RE: Notice of Exhibition – Moorebank Precinct West Stage 2 (SSD 7709)

In response to the exhibition material, Campbelltown Council makes the following comments:

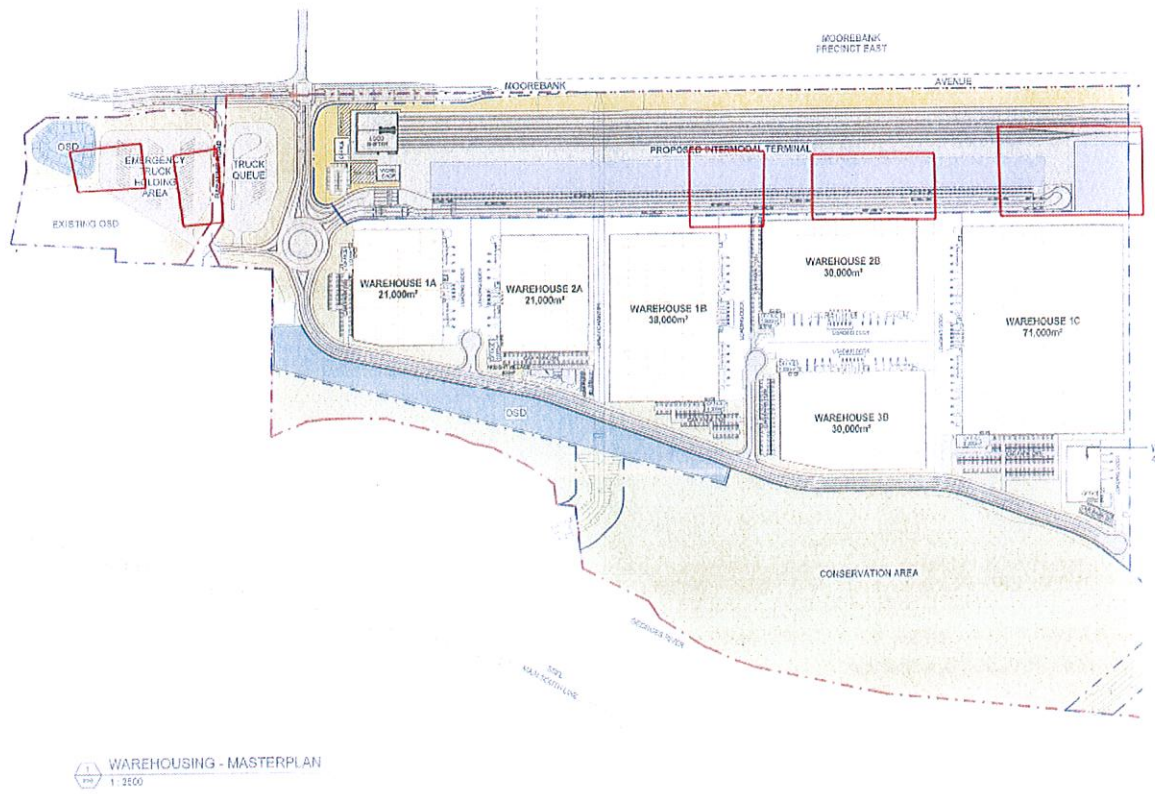
1.3 Truck right-turn movements from terminal onto Moorebank Avenue heading south

The proposed intersection design with Moorebank Avenue/Anzac Road appears to be inconsistent with the concept approval (SSD 5066) for the facility, refer to Schedule 4 – Condition E12:

All future Development Applications shall demonstrate how the main access to the site has been designed to prevent heavy vehicles associated with the facility from using Moorebank Avenue South, and should be accompanied by detailed engineering drawing(s).

Appendix 'G' to the current application clearly demonstrates that the intersection has been made viable for trucks (a-doubles maximum) to turn right onto Moorebank Avenue and head south, which is not considered to be compatible with the concept approval.

Even if the proponent suggests that the trucks would be heading in that direction to access Precinct East only and not continuing on to utilise the Cambridge Avenue Georges River crossing, the fact remains that the proposal is not consistent with the condition and there are no safe-guards proposed, aside from 'education of drivers' accessing the terminal. It could be argued that if the PAC considered driver education to be sufficient, that the wording of Condition E12 would have been different.
